STAFF REPORT
WEST ALLIS PLAN COMMISSION
Wednesday, January 25, 2023
6:00 PM

- 3A. Conditional Use Permit for Chase Bank, a proposed Neighborhood Service with accessory drive-through service, to be located at 2678 S. 108th St.**
- 3B. Site, Landscaping, and Architectural Plans for Chase Bank, a proposed Neighborhood Service with accessory drive-through service, to be located at 2678 S. 108th St. (Tax Key No. 485-9990-009)**
Items 3A and 3B may be considered together.

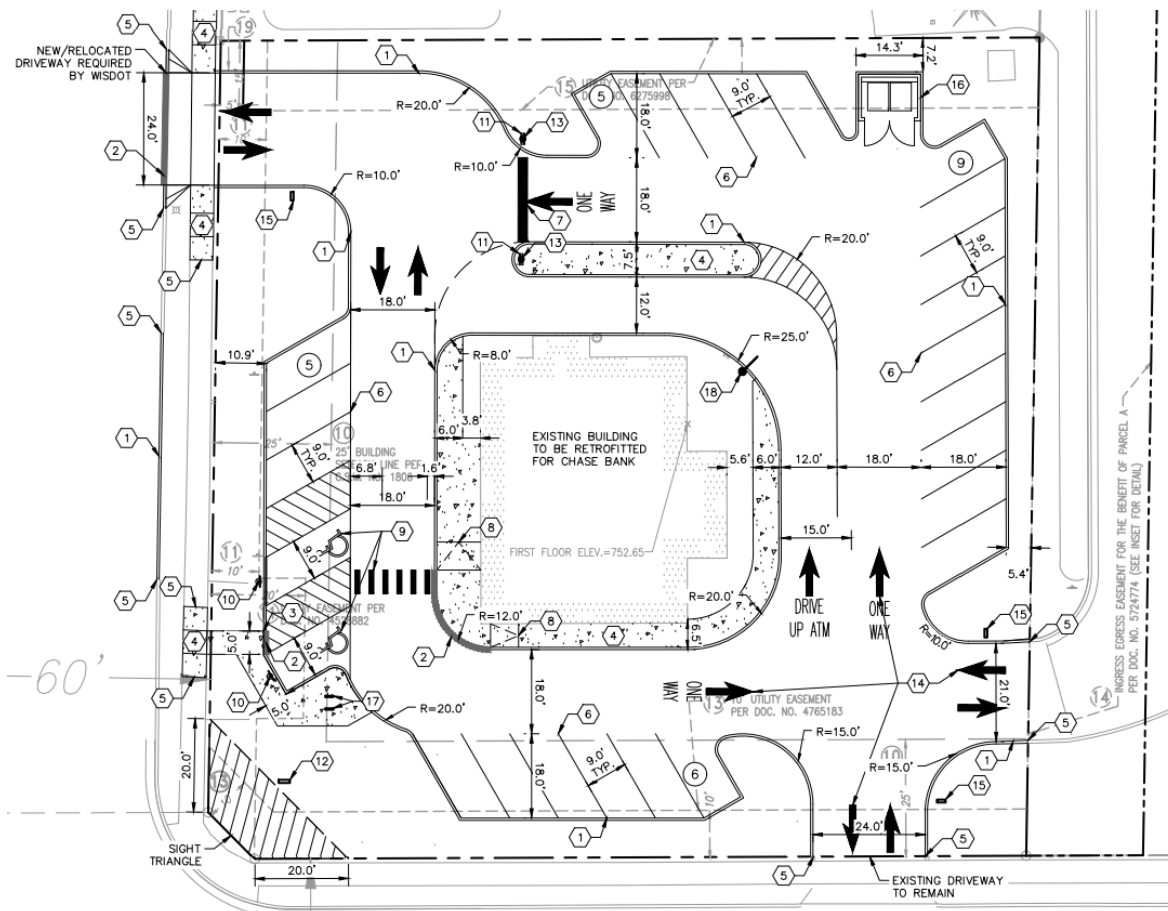
To prepare the site, Chase Bank proposed several changes to the layout of the Parking lot. Staff noted that the site does not comply with Sec. 19.44(2) of the zoning code. The zoning code allows up to 3 parking spaces per 1,000 sq. ft. of gross floor area open to the public for service uses. Therefore, no more than 8 parking spaces are allowed for this property.

The site was built prior to the adoption of this regulation and is a legal nonconforming use. Because changes are proposed to the noncompliant parking lot, staff requested Chase Bank to eliminate parking stalls to come into compliance with the Code. Chase Bank noted that 8 parking spaces is not enough to fit the needs of the bank. Chase Bank

offered to compromise at 25 spaces, a reduction from the sites original 39 spaces. Staff supports this compromise.

The proposed changes to the parking lot include relocation of the existing curb cut on the west side of the property further north and reorganization of parking spaces. Parking stalls have been removed on all edges of the property with additional landscape areas given on the Southwest corner of the site. A sidewalk connection has been added on the Southwest edge of the parking lot.

1. Common Council approval of the Conditional Use Permit (I think we need to schedule a date for the public hearing yet).
2. Revised site and landscaping plan being submitted to the Planning and Zoning Office to indicate the following:
 - a. Notation on the site plan to indicate removal of the existing non-conforming pole sign
 - b. Updated landscaping plan being approved by the City Forester.
3. A surety bond or letter or other form of security as required under Sec. 19.13(2)(e) of the Revised Municipal Code in the amount of 125% of landscaping and screening shall be executed by the applicant prior to the issuing of a building permit.
